REMARKS

THE OFFICE ACTION:

Figure 3

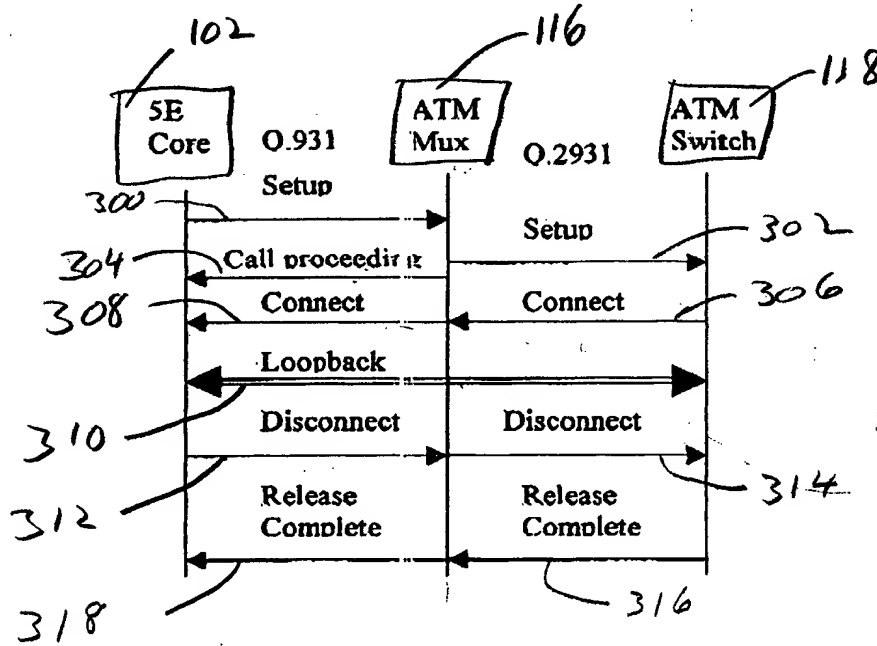
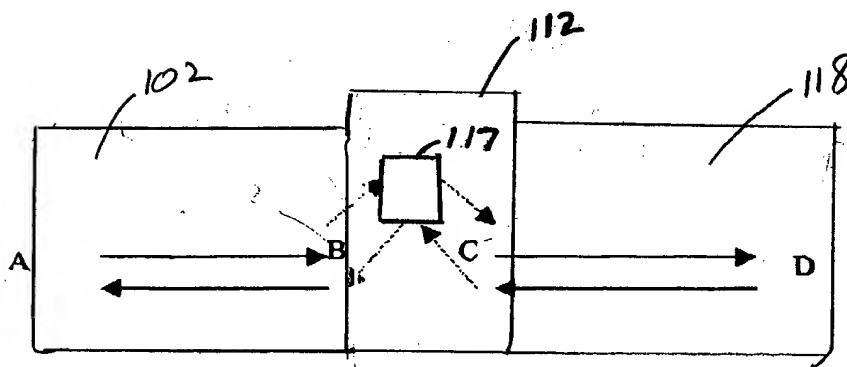
The Examiner has objected to the drawings under 37 C.F.R. 1.83(a). More specifically, the Examiner states that "interworking facility, IPDC, egress port, and routing table" must be shown in the drawings or canceled from claims 3-6, 12, and 14.

Claims 3 and 14 have been amended to recite that the interwork unit provides an IPDC capability. Fig. 3 shows Q.931 messages communicated between the 5E core 102 and the ATM multiplexer 116. The originally-filed specification identifies

that Internet Protocol Device Control (IPDC) may be used for these communications instead of Q.931 (see page 9, lines 13-16). Hence, the drawings show the IPDC feature of the invention specified in the claims.
